STAFF REPORT COVER SHEET

Addresses:	100-112 Maple Ave E	Case Number:	PF-59-18-MAC
Public Meeting Date:	4/24/2019	Applicant:	Sunrise Development Inc.
Board/Commission:	Planning Commission	Owners:	Kirschner Enterprises Inc,
Existing Zoning:	C-2, C-1A	Existing Land Use:	Office
Brief Summary of Applicant Request:	Request for a rezoning to the Maple Avenue Commercial (MAC) zoning district, approval of four modifications of requirements, and a conditional use permit for assisted living. Applicant proposes a mixed-use building with retail space on the ground floor and senior assisted living facility above.		
Site Improvements:	Redevelopment of existing site to include approximately 5,700 square feet of commercial/retail space and 83 unit senior assisted living facility. Improvements also include at-grade structured parking and one level of underground parking.		
Size of Property:	32,130 sf/0.74 acres		
Public Notice Requirements:	Advertisement for two successive weeks of public hearing in a newspaper having paid general circulation in the Town	Published in Washington Times on April 10, 2019 and April 17, 2019

ITEMS NO. 1, 2 & 3:

Recommendation by the Planning Commission to the Town Cou

Figure 6 – Section A-A from Sheet P-0301A from the applicant's concept plans

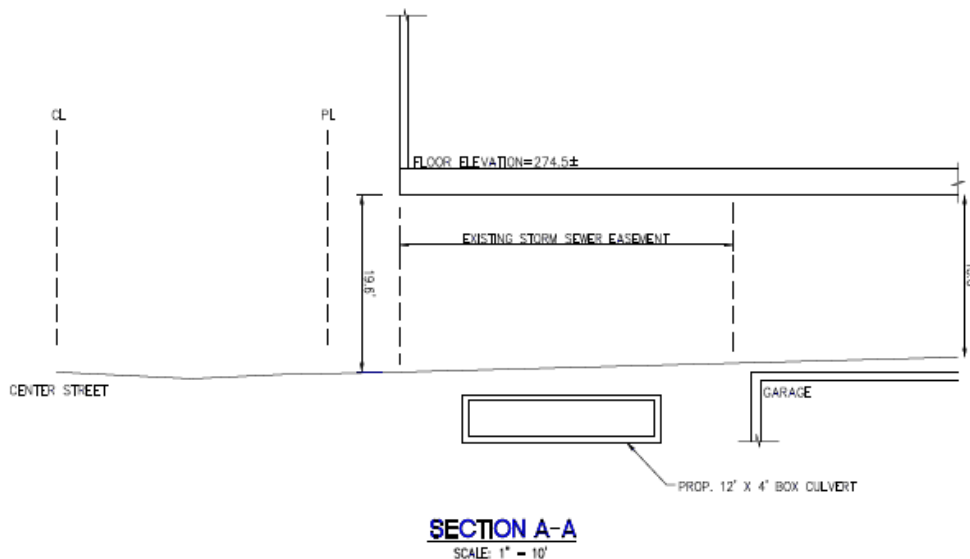
One of the implementation strategies for providing infrastructure to Town residents and businesses includes “require new developments to fund improvements to the water and sewer systems through fee and development conditions” (page 110). The proposed building will be located over an existing easement for twin 66-inch storm sewer pipes that diagonally cross the western corner of the property. Staff is concerned about future access to the 66-inch pipes under the property once the building is constructed, as any work to update the culvert would block the only vehicular entrance to the site. The replacement of the box culvert is proposed in later year capital improvement projects, however, not before the proposed construction of this site if approved. The applicant has agreed to replace the existing 12-foot by 4-foot box culvert during construction of the site. The applicant has added a cross section of the location of the box culvert in relation to the proposed underground parking garage. An existing 10-inch sanitary sewer line bisects the property from the south to the north. The applicant is proposing to relocate the sewer line along the eastern edge of the property under the proposed pocket park in a proposed 20-foot easement.

Figure 7 – Green Roof Diagram from Sheet P-0501 from the applicant's concept plans

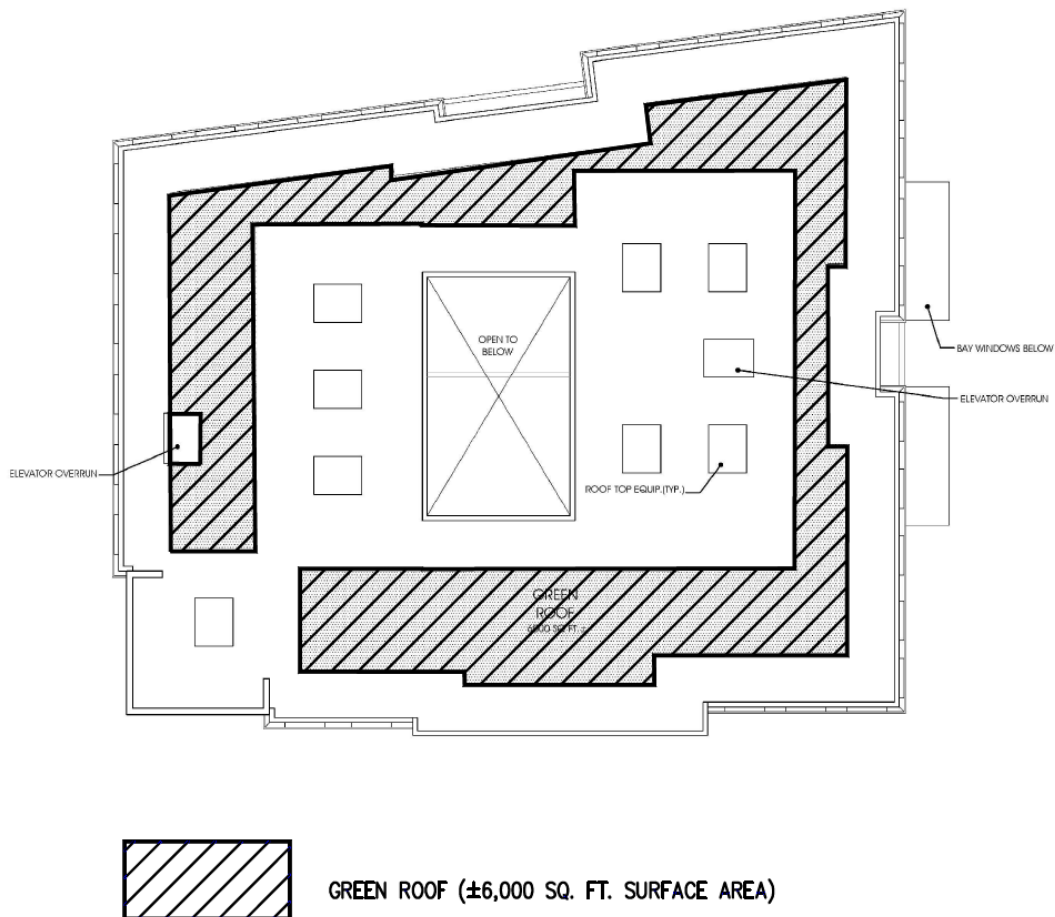
The Comprehensive Plan also recommends encouraging “the use of low impact development technology as a planning and design strategy to manage the quantity and quality of stormwater runoff” (page 110). The applicant is proposing a 6,000 square foot green roof system to manage the quantity and quality of the stormwater. The applicant has stated the proposed Best Management Practices (BMPs) including the green roof, hydrodynamic separator and permeable pavement will remove 0.33 pounds of phosphorous per year, 10 percent more than the state requirement.
